Application for Works Approval

Works Approval Number	W6930/2024/1
Applicant	South West Irrigation Management Co-Operative Limited
ABN	54 498 176 490
File number	DER2023/000758
Premises	Harvey Dam Legal description – Part lots: Lot 622 on Deposited Plan 31967. Certificate of Title Volume 2532 Folio 383 Lot 637 on Deposited Plan 31967. Certificate of Title Volume 2532 Folio 390 Lot 3004 on Deposited Plan 38418. Certificate of Title Volume 2639 Folio 252 Lot 642 on Deposited Plan 44762. Certificate of Title Volume 2596 Folio 12 As defined by the premises maps attached to the issued works approval
Date of report	27 November 2024
Decision	Works approval granted

Figure 1: Water balance assessment

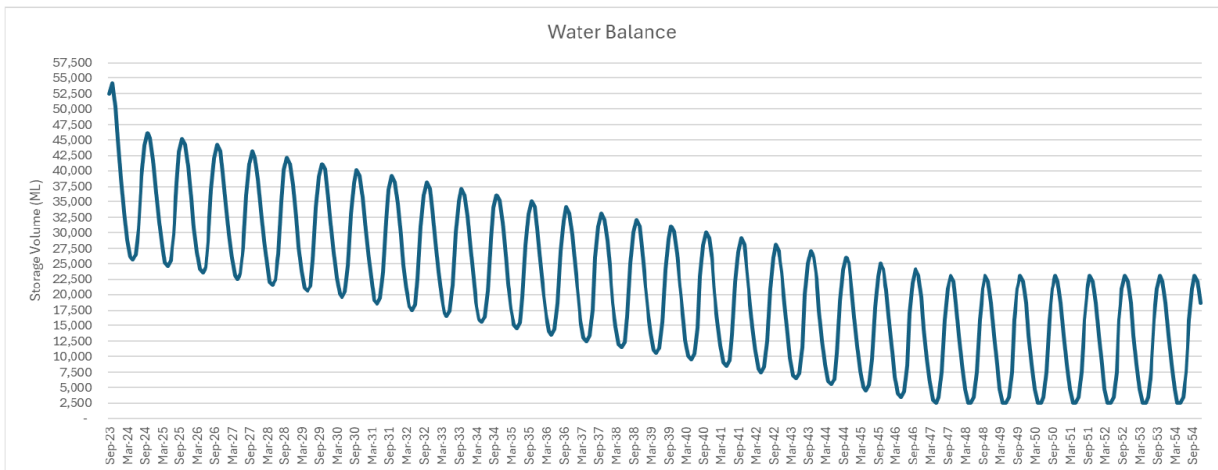
The Delegated Officer notes that it is not possible to accurately predict with high certainty the water balance for the Harvey Dam. The applicant's plan to review and update the assessment every 5 years is supported. The water balance developed by the applicant is supported by climate predictions and the updated guidelines for using future climate projections for water management (DWER 2024).

The graphs presented in the application package depict a declining trend in water balance. The water balance depicted shows a water balance developed from a narrower period (2013-2022) than the complete data set 2002-2024 as released by the Water Corporation.	<p>The Delegated Officer notes that it is not possible to accurately predict with high certainty the water balance for the Harvey Dam and the applicants plan to review and update the assessment every 5 years is supported. The water balance developed by the applicant is supported by climate predictions and the updated guidelines for using future climate projections for water management (DWER 2024).</p> <p>It should be noted that future licence application may be subject to further regulatory controls for reviewing and updating the water balance assessment.</p>

Figure 2: Dilution modelling for Total Nitrogen

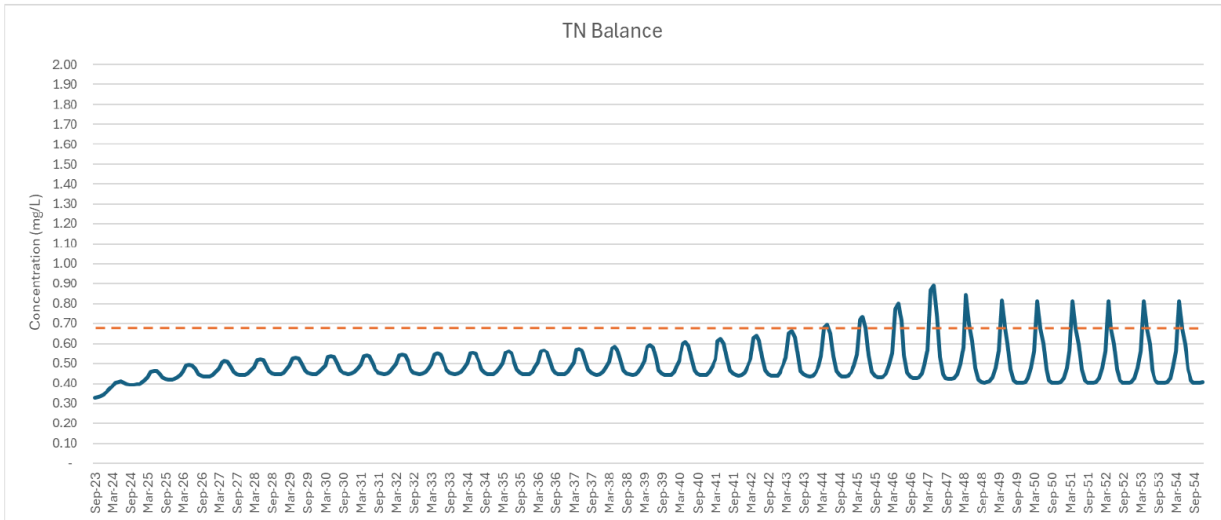
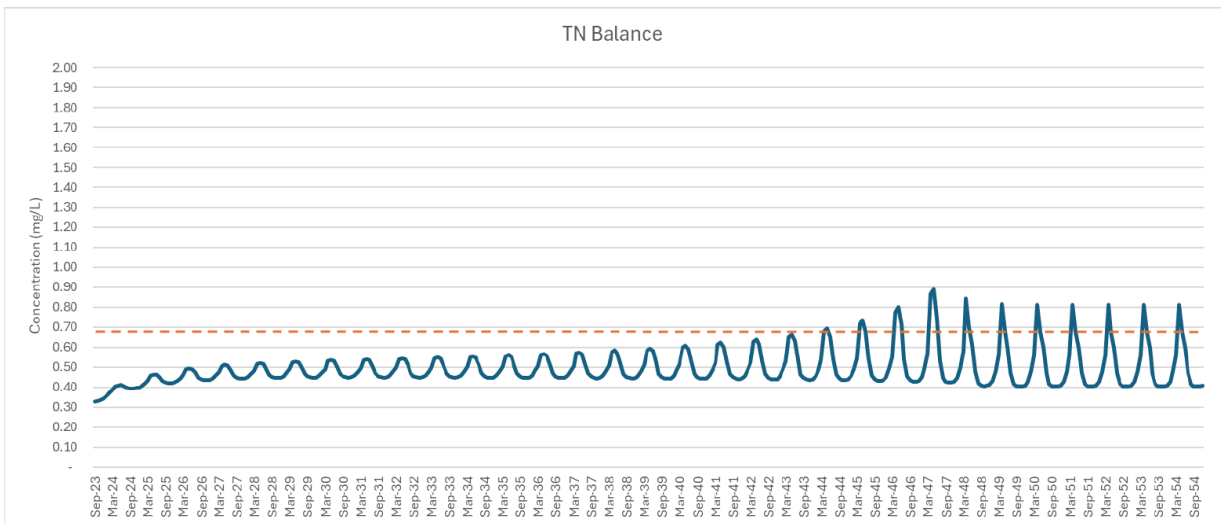
- Total Nitrogen modelling indicates that a potential non-compliance with the calculated 80th percentile trigger values of 0.68 mg/L in May 2044;
- Total Phosphorous modelling predicting a potential non-compliance with the calculated 80th percentile trigger values of 0.025 mg/ in May 2047;

- Calculations in the WQMP assume the treated wastewater will be well mixed within the entire Harvey Dam, however this is unlikely given the close proximity between the treated wastewater diffuser and the outlet point.
